STAFF REPORT

CITY OF COLUMBUS PLAN COMMISSION (April 8, 2026 Meeting)

Docket No. / Project Title: SUB-26-20 (Tipton Ridge Major Subdivision Preliminary Plat)
Staff: Andres M. Nieto
Applicant: Tim Thomas, PE
Property Size: +/- 107 acres
Current Zoning: RS4c (Residential: Single-family 4) w/ commitments
RMc (Residential: Multi-family) w/ commitments
Location: 7162 West State Road 46, in the City of Columbus.

COUNTY ROAD 500 W & DOGWOOD WAY INTERSECTION
1"=30'

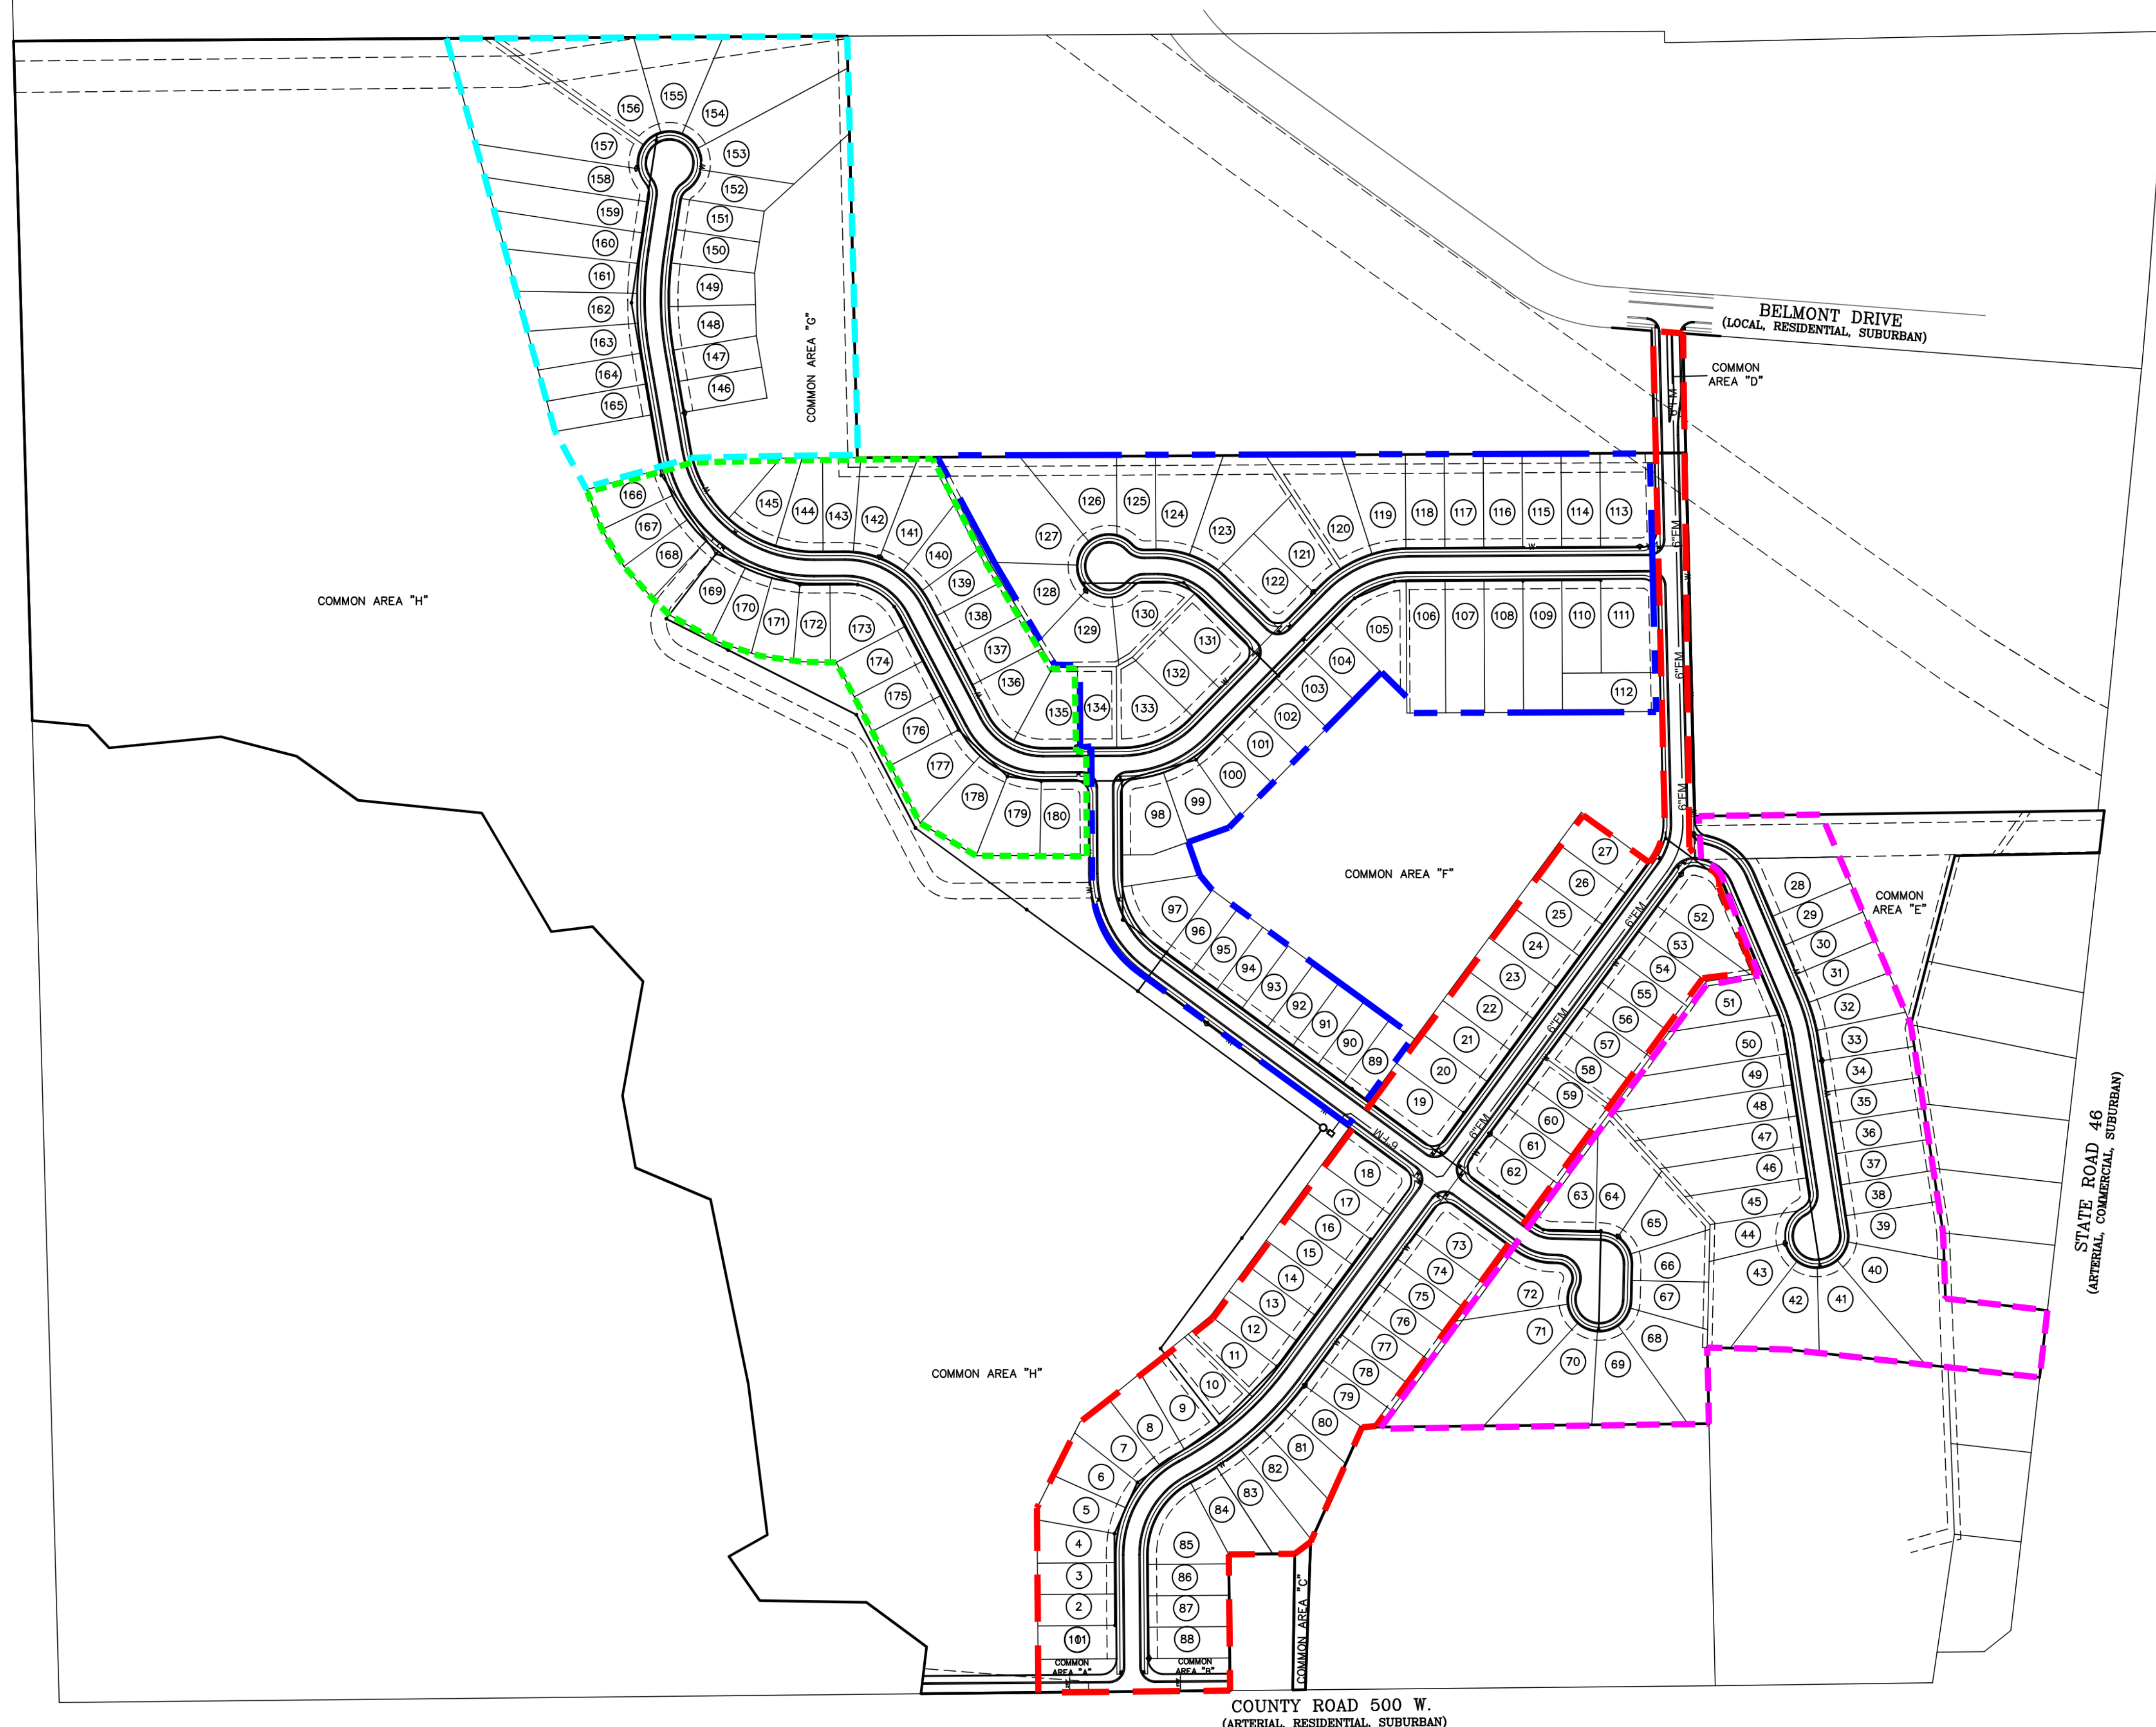
12. Sheet C15:
 - a. The 500 West cross-sections shall be revised to show a half right-of-way to match Sheets C3 and C8, and the "Proposed additional ROW" shall be revised to match Sheets C3 and C8, as well.

- b. The utility easement shown on the intersection detail of 500 West and Dogwood Way shall extend across the whole 500 West frontage of the site, rather than just being shown within the Common Area.

- d. In the intersection detail of Dogwood Way and Belmont Drive, curb ramps shall be shown on both sides of Belmont Drive located on the north side of Dogwood Way.
